DATE	REVISION	LOCATION	COMMENT
14 MAY 2025	A		INITIAL ISSUE AND VERIFICATION.
21 MAY 2026	B	B5–B7	ADDED 'SUCKBASS' SWITCH AND ADD'L COMMENTS

TX–1 VACUUM–TUBE AGONIZER

Size: USLegal	Date: 2026–05–21	**Rev: B**
KiCad E.D.A. 10.0.1		Id: 1/1

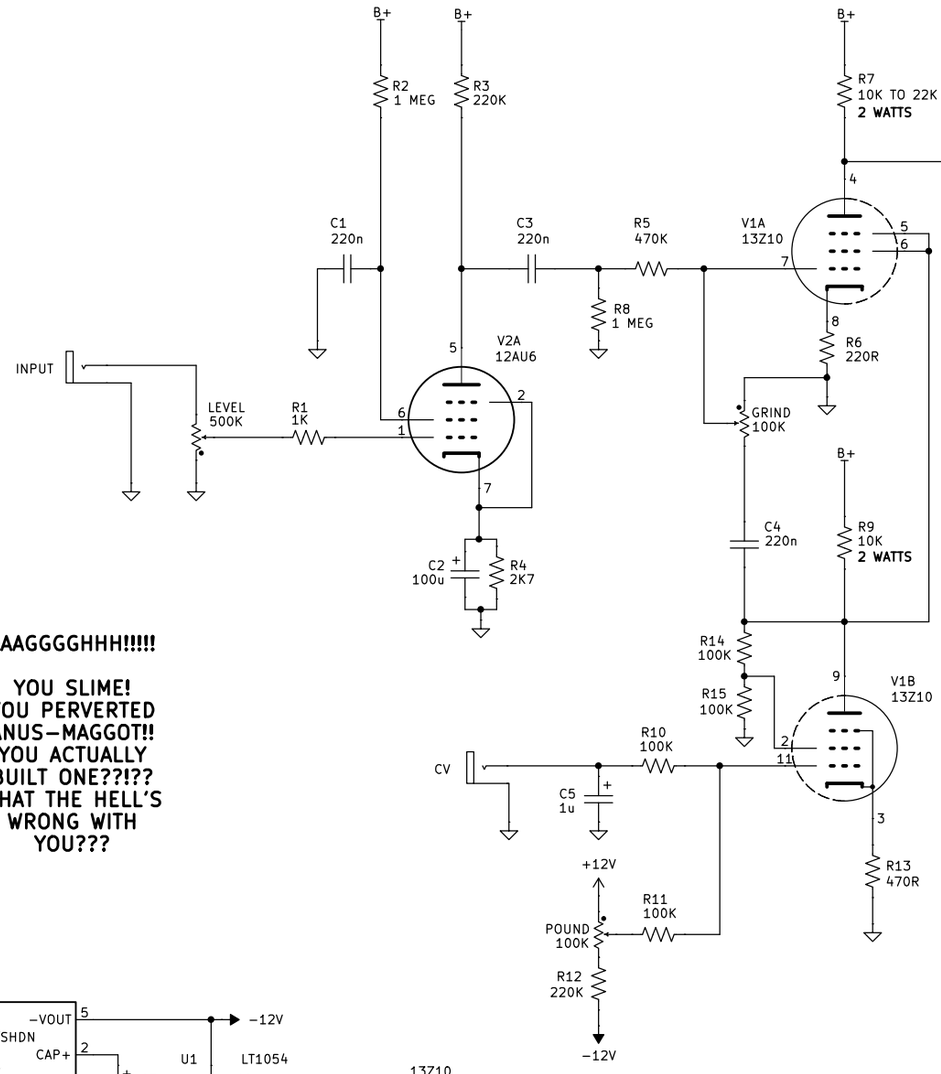
ORIGINAL CIRCUIT DESIGNED FOR ~~+50VDC,~~ **+100VDC** BUT MAY BE OPERATED AS LOW AS 48 VDC OR AS HIGH AS 200 VDC. THE SOURCE, TOPOLOGY, QUALITY, AND RELIABILITY OF THIS VOLTAGE AS WELL AS THE CORRECT RE–RATING OF RELEVANT COMPONENTS IS THE RESPONSIBILITY OF THE BUILDER. IF THE BUILDER DOESN'T KNOW HOW TO SAFELY GET THAT VOLTAGE OR HOW (AND WHY) TO RE–RATE COMPONENTS, THE BUILDER IS STRONGLY ADVISED TO RECONSIDER CONSTRUCTING THIS CIRCUIT.

OPTIONAL:
SPECIAL UNACCEPTABLE EDITION
'SUCKBASS' SWITCH – REPLACE C6
WITH THIS BLOCK

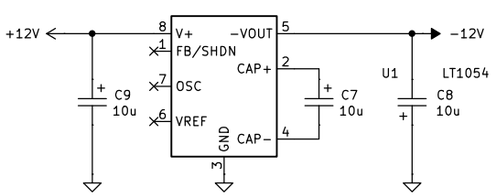
Eric on 'SUCKBASS' switch:
"Secrets"? It was just a smaller value coupling capacitor on the output, a switch put in a larger value. No I don't remember what they were."

I believe the original 220n coupling cap gives a −3 dB high pass cut of 2.8 Hz

$$f_c = \frac{1}{2\pi RC}$$, with R = R16 + R17)

C11 VALUE	HP CUTOFF (rounded to nearest whole number)
10nF	60 Hz
4.7nF	127 Hz
2.2nF	271 Hz
1nF	596 Hz
500pF	1.1 kHz
